World Forum for Harmonization of Vehicle Regulations

Working Party on Passive Safety

Regulation No. 95 (Lateral collision)**Proposal for 03 series of amendments to Regulation No. 95****Submitted by the expert from France***

Figure 1: Measurement of Vb, V1, V2, V3

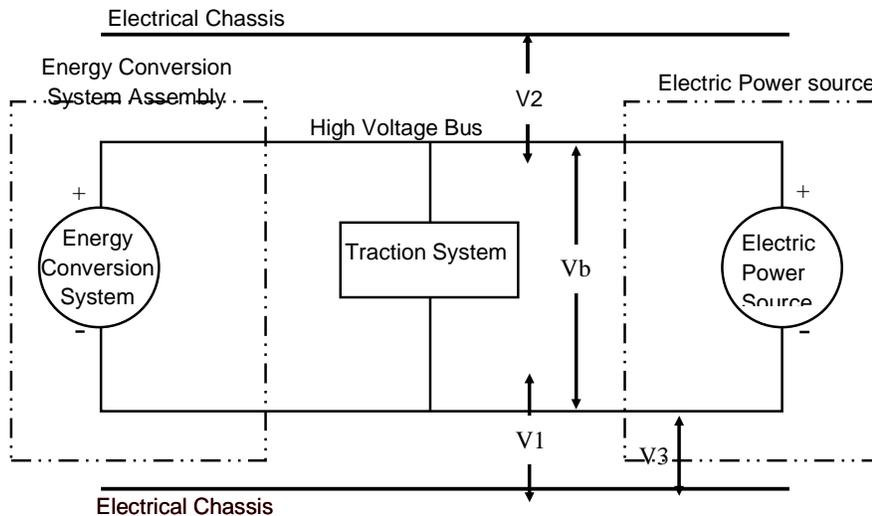
2. The following instructions may be used if voltage is measured. After the crash test, determine the high voltage bus voltages (Vb, V1, V2) (see figure 1). If the RESS has exposed conductive parts, measure the voltage V3 between any exposed conductive parts of it and the electrical chassis.

[The measurement shall be made at 5 seconds after the impact]

Figure 2: Measurement of high voltage bus energy

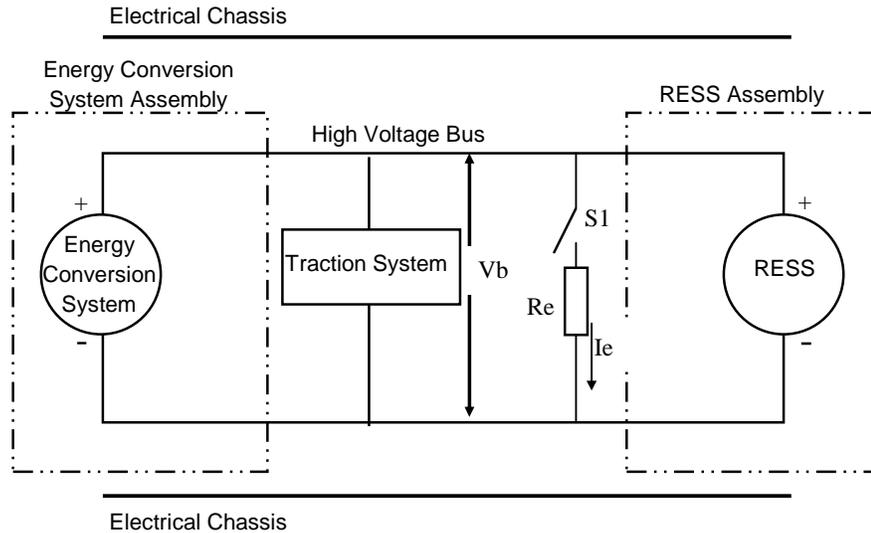
Prior to the impact a switch S1 and a known discharge resistor Re is installed according to figure 2. [At 5 seconds] after the impact the switch S1 is closed while the voltage Vb and the current Ie is measured and recorded. The product of the voltage Vb and the current Ie is integrated

over the period of time starting from the moment when the switch S1 is closed (t_c) until the voltage V_b falls below the high voltage threshold of 30 V AC or 60 V DC (t_h), resulting in the total energy (TE) in joules.

Figure 3: Measurement of V1'

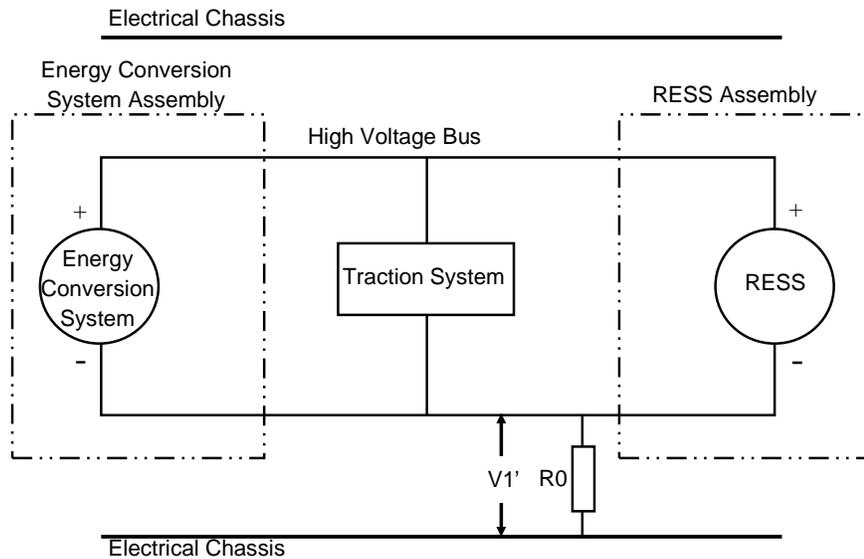
If V1 is greater than or equal to V2, insert a standard known resistance (Ro) between the negative side of the high voltage bus and the electrical chassis. With Ro installed, measure the voltage (V1') between the negative side of the high voltage bus and the vehicle electrical chassis (see Figure 3). Calculate the isolation resistance (Ri) according to the formula shown. Divide this electrical isolation resistance value (in Ω) by the working voltage of the high voltage bus (in volts).

Figure 4: Measurement of V_2'

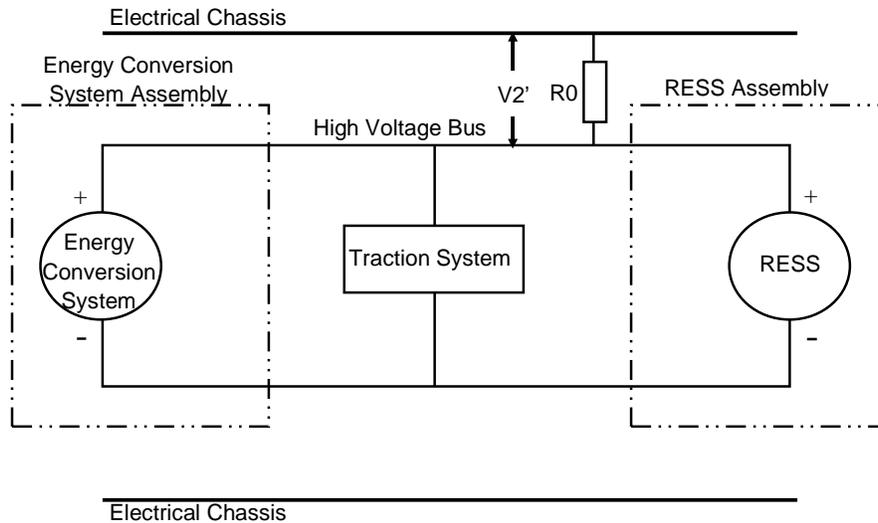
If V2 is greater than V1, insert a standard known resistance (Ro) between the positive side of the high voltage bus and the electrical chassis. With Ro installed, measure the voltage (V2') between the

positive side of the high voltage bus and the electrical chassis (see figure 4).

Calculate the isolation resistance (R_i) according to the formula shown. Divide this electrical isolation value (in Ω) by the working voltage of the high voltage bus (in volts).

Figure 1: Jointed test finger

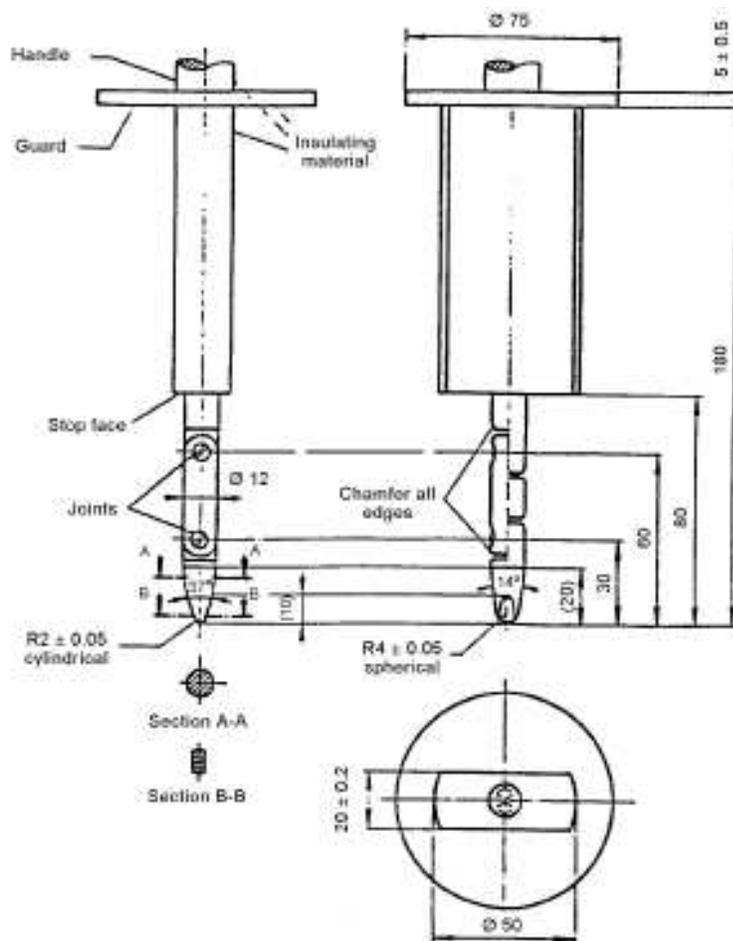
In the case of the test for IPXXB, the jointed test finger may penetrate to its 80 mm length, but the stop face (diameter 50 mm x 20 mm) shall not pass through the opening. Starting from the straight position, both joints of the test finger shall be successively bent through an angle of up to 90 degree with respect to the axis of the adjoining section of the finger and shall be placed in every possible position.
